**AGENDA
FARRAGUT MUNICIPAL PLANNING COMMISSION**

**November 15, 2018
7:00 p.m. Farragut Town Hall**

Re: Staff comments on site plan for Way Station Road Extension

**RE: Cath Lab, OB, CCU, and Connector Addition and Renovation at Tennova Turkey Creek Medical Center—Site Plan Review Comments Response
Knoxville, TN**

SITE PLAN

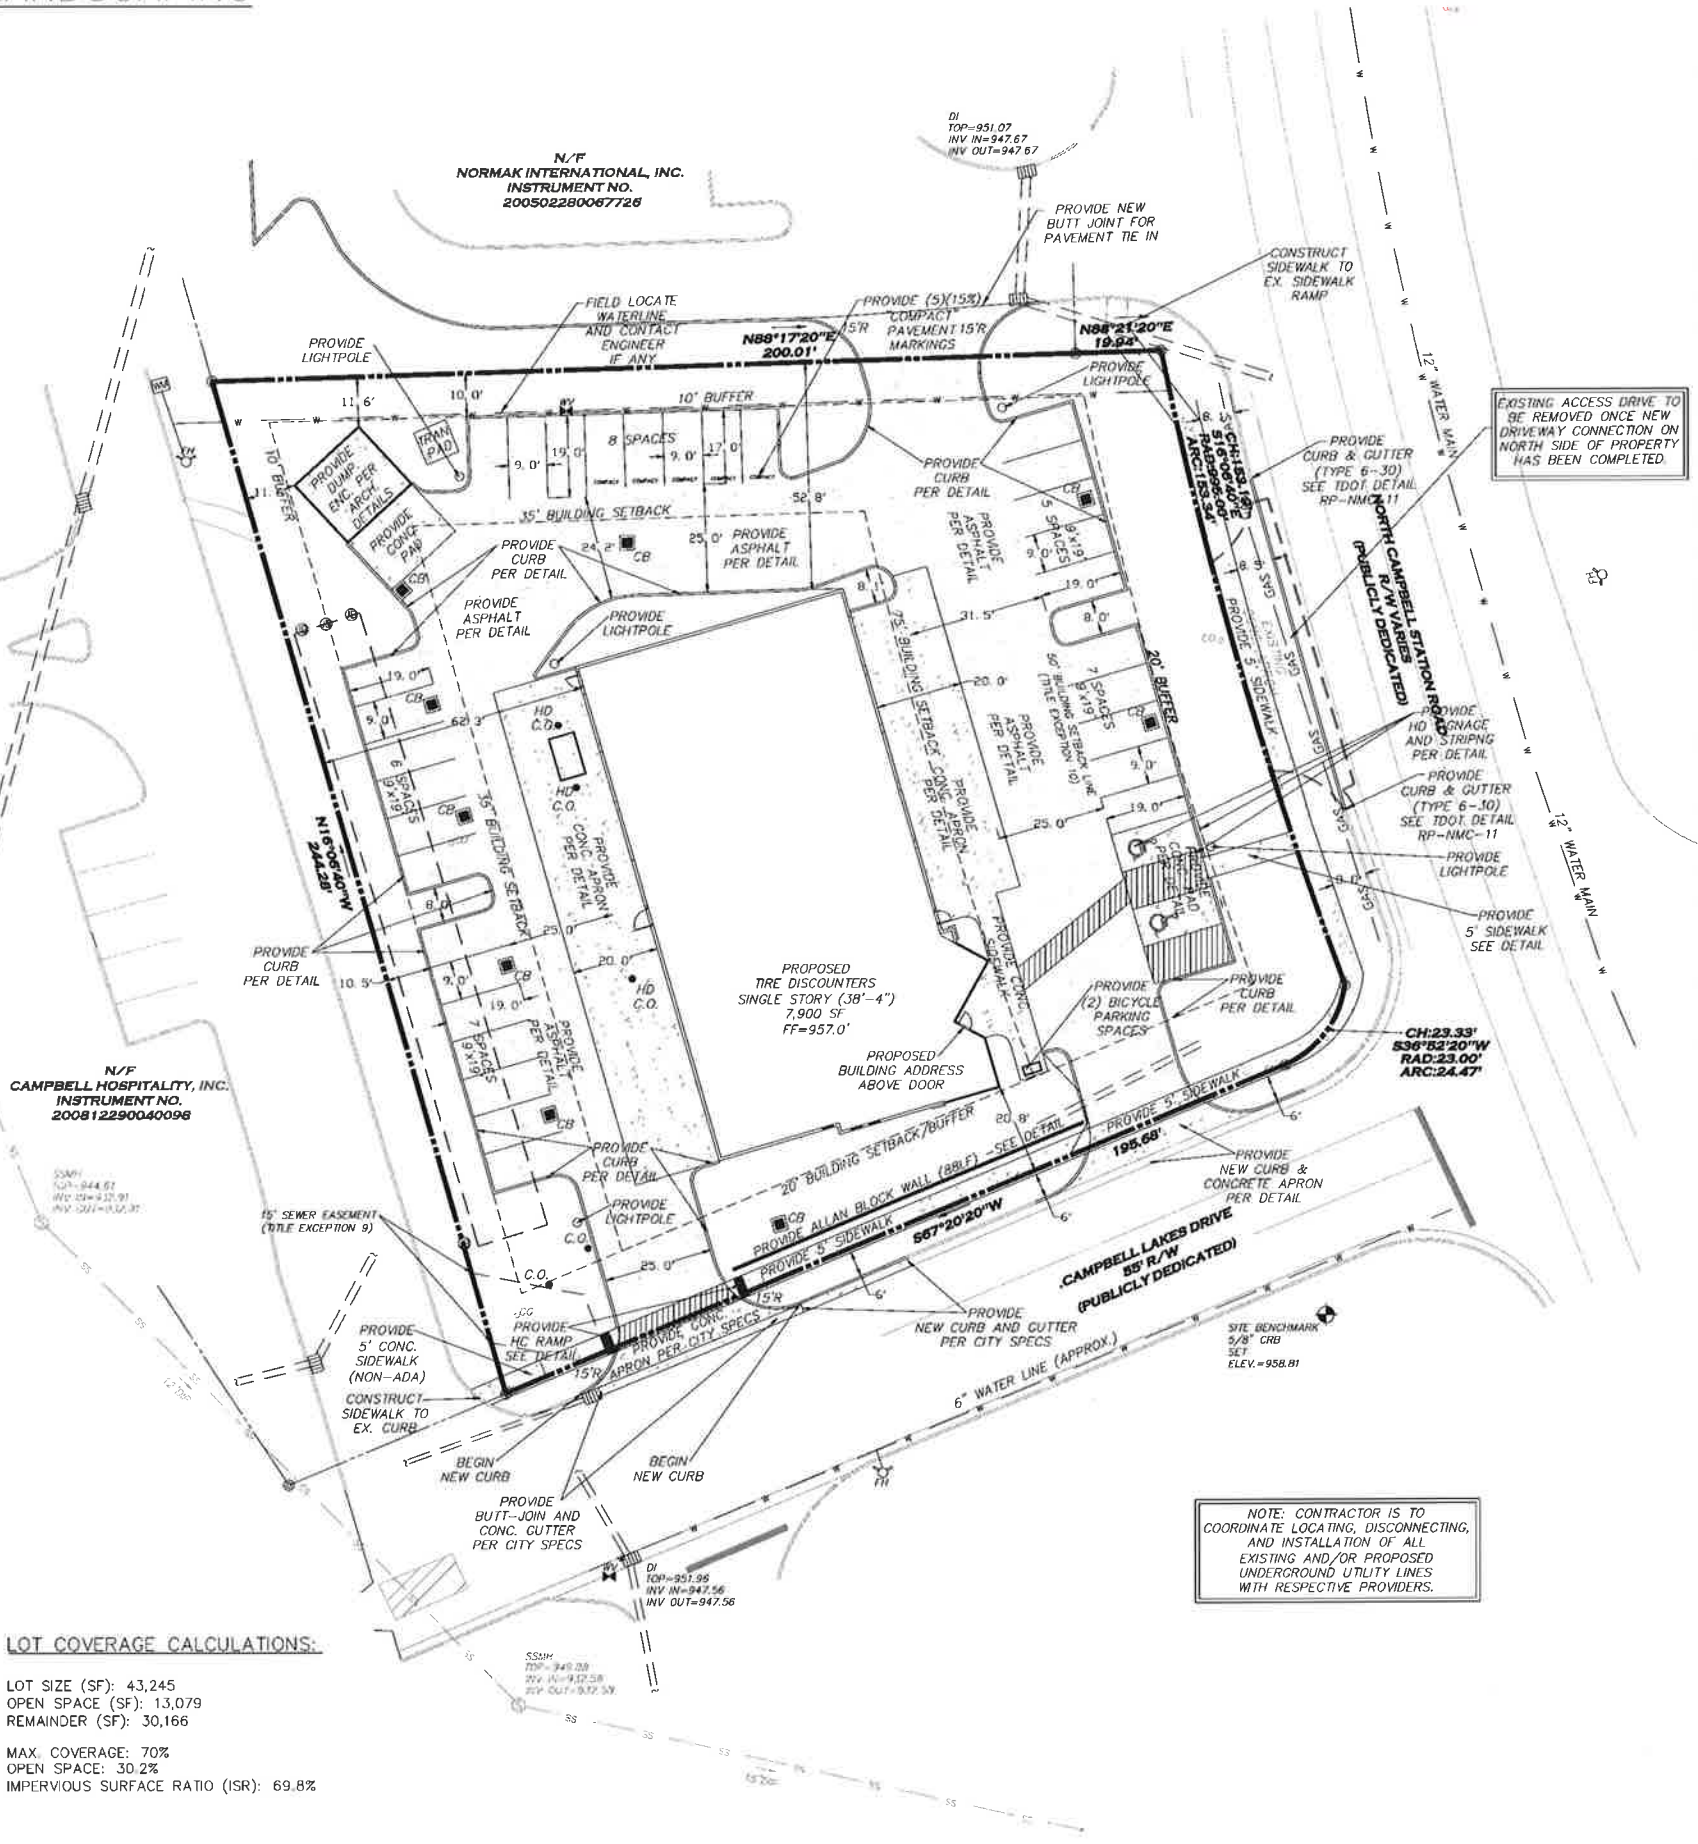
At this time the applicant is requesting a second full access along Campbell Lakes Drive with the nearest portion of the proposed curbline being approximately 55 feet from the nearest existing curbline of N. Campbell Station Road. This access is being requested as a condition of approval from the property owner to the north of the cross access between the two properties. The owner to the north wishes to have the full access so that patrons leaving his development will not have to drive behind the Tire Discounters building to exit the property onto Campbell Lakes Drive.
